Re substitute consent for Cleanrath wind-farm – ABP 306272-19

I ask that you refuse the application for substitute consent for Cleanrath wind-farm.
I am house A (C04) recognised sensitive location

Figure 11-1: Location A

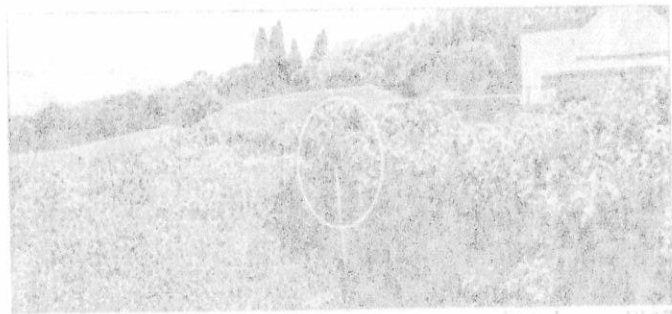
It has been acknowledged that the background noise monitor should not have been positioned by vegetation as it will have picked up additional noise due to the foliage. (see photo). Even given this the EIA shows a massive difference between recorded background and allowed operational noise. It can't be reasonable to allow a fixed 40dB, 43dB, 45dB against such low background noise.

Page 11-41 of the EIA shows measured noise. The turbines were off more times than they were on during the operational measuring phase, and rarely operating together, so this can't be considered full data. I was told at the point of removal of the equipment that it was only being taken away as the turbines had to be turned off.

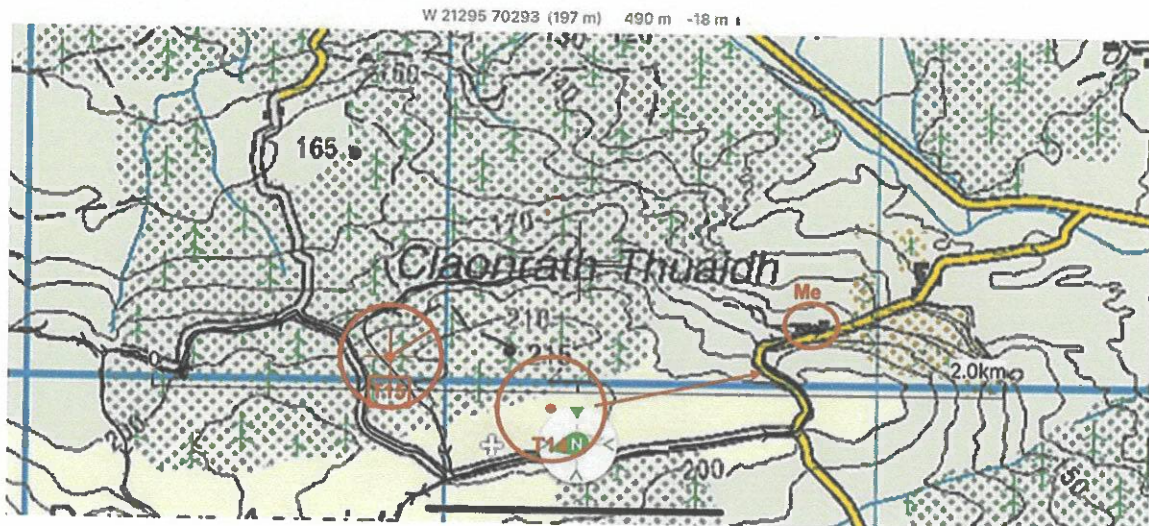
I checked using viewranger: here's the elevation of T14 in relation to where the water is running off the hill. The arrow marks the point that the water runs out onto the road. I would suspect that the removal of the porous material at T14 and surrounds might be impacting, or that water run off has become diverted. I haven't seen damage at the point the water enters the road before 2019.

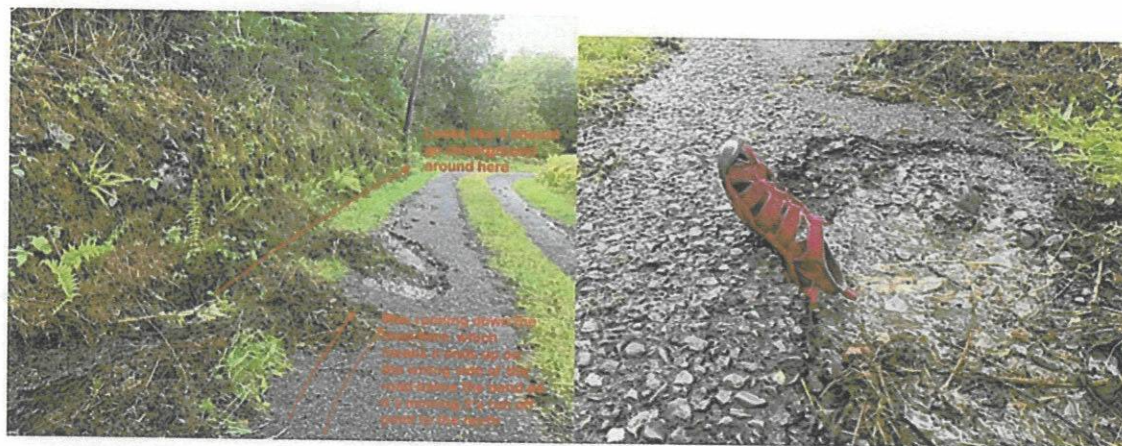
These photos are taken August 19 and shared with James Dwyer engineer for Macroom
council, who had asked that I try and identify source/route of water. Road was subsequently
fixed 2019 but recent run off has caused new damage to road.

Debris washed down road and into my gate - water eroded hole at back of my house, water
entered here ending up under my house

Star marks where the arrow points to on first pic. Runs off hill onto road.
 The remainder of the photo's track the route of the water down road past my house.

View from my house T14 & T15

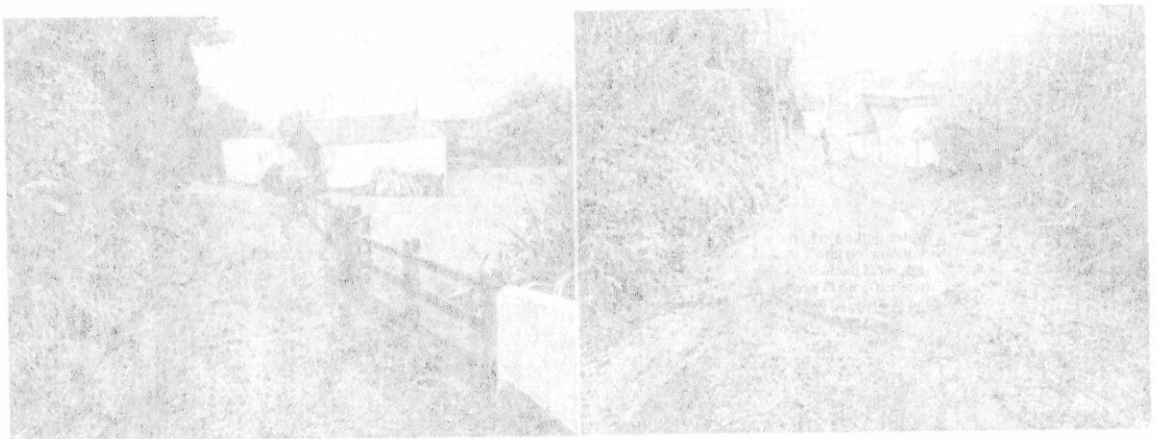
Visibility: The turbine site dwarfs my home on approach. T14(T3) and T15(T1) have a visually imposing impact at my home

Star marks where the arrow points to on first pic. Runs off hill onto road.
The remainder of the photo's track the route of the water down road past my house.

I had to get a pointy shovel and dig the ditch out to divert the water on this occasion, to
minimise impact to my house
